BEFORE THE PATENT TRIAL AND APPEAL BOARD

Ex parte BIN GENG

Appeal 2018-001946
Application 14/454,896
Technology Center 3600

DECISION ON APPEAL

A portion of original Figure 4A is shown above on the left, including operable bar 10, and the coinciding portion of amended Figure 4A, shown on the right, having a rectangular hole formed in operable bar 10 about pivot shaft 9.

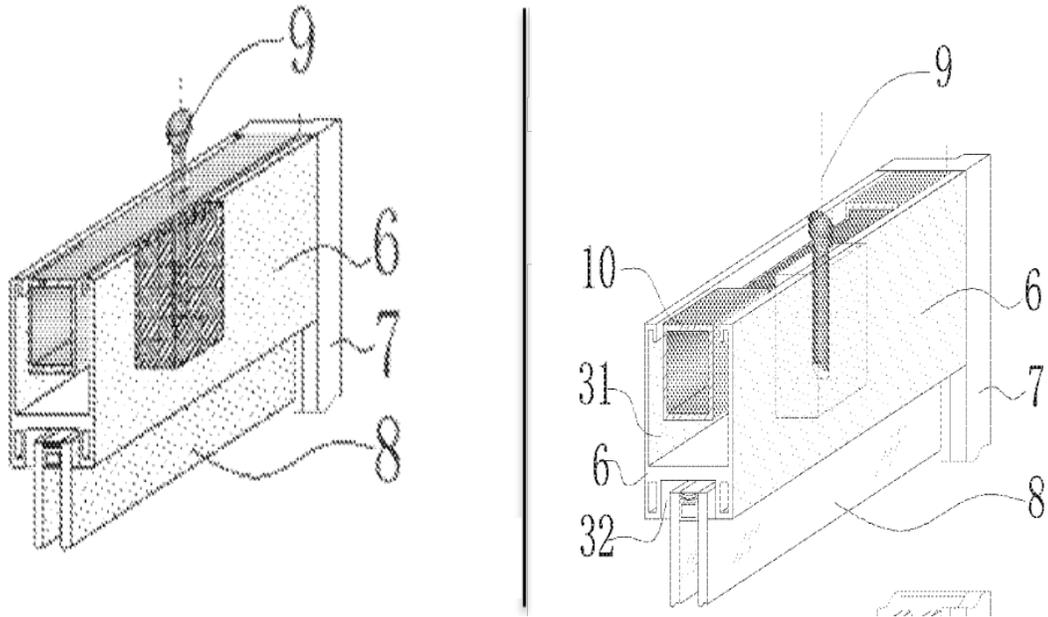
[t]he added material which is not supported by the original disclosure is as follows: the large rectangular hole in operable bar 10 in figures 3B, C, D, 4B and C was not shown in the original figures. The original figures clearly show only a small circular hole around pivot shaft 9 in figure 4B that is not large enough to engage wheel assembly 13.

Appellant argues specifically that although the operable bar 10 shown in the original figures is non-functional, "FIG. 4[A] must be an obvious error, because even a patent examiner can recognize the non-functionality." *Id.* at 10. Original Figure 4A and amended Figure 4A are reproduced below.

We are not persuaded that the drawing error, as it is acknowledged by Appellant, can be corrected by this drawing amendment. The drawing amendment adds an entirely new element to the drawings and the disclosure, that is—a rectangular hole, formed in operable bar 10. The rectangular hole amendment is intended, we understand, to illustrate a structural feature that would allow operable bar 10 to essentially overlap trolley 13—instead of simply butt up against the lower-most surface of the trolley. Appeal Br. 10–11. Appellant does not, however, point to any support in the written description for this rectangular hole structure, nor does our review of the Specification reveal any such language expressly or inherently discussing such structure. We appreciate that addition of this rectangular hole structure

might permit operable bar 10 to overlap trolley 13, but neither the written description, the original drawings, nor Appellant's argument that the error is obvious, provide persuasive evidence that the inventor was in possession of such a structure and device as shown in the amended Figure 4A at the time of filing of the patent application. Also, Appellant's reliance on *In re Oda* is misplaced. *In re Oda* addresses mainly the issue of a translation error and not issues of new matter raised by the addition of new elements to the specification and drawings. Moreover, *In re Oda* also requires not only that the error be obvious, but that *the solution* to the error must be obvious to a person of ordinary skill in the art. *See In re Oda*, 443 F.2d at 1206 (Overturning the new matter rejection, the court explained "that one skilled in the art would appreciate not only the existence of error in the specification but . . . how to correct it."); MPEP § 2163.07. Appellant's suggestion that the rectangular hole in operable bar 10 as shown in amended Figure 4A could fix the error in the original drawings does not explain sufficiently why the rectangular hole must have been the obvious correction to one of skill in the art.

We sustain the Examiner's objection under 35 U.S.C. § 132(a) to the amended drawings.
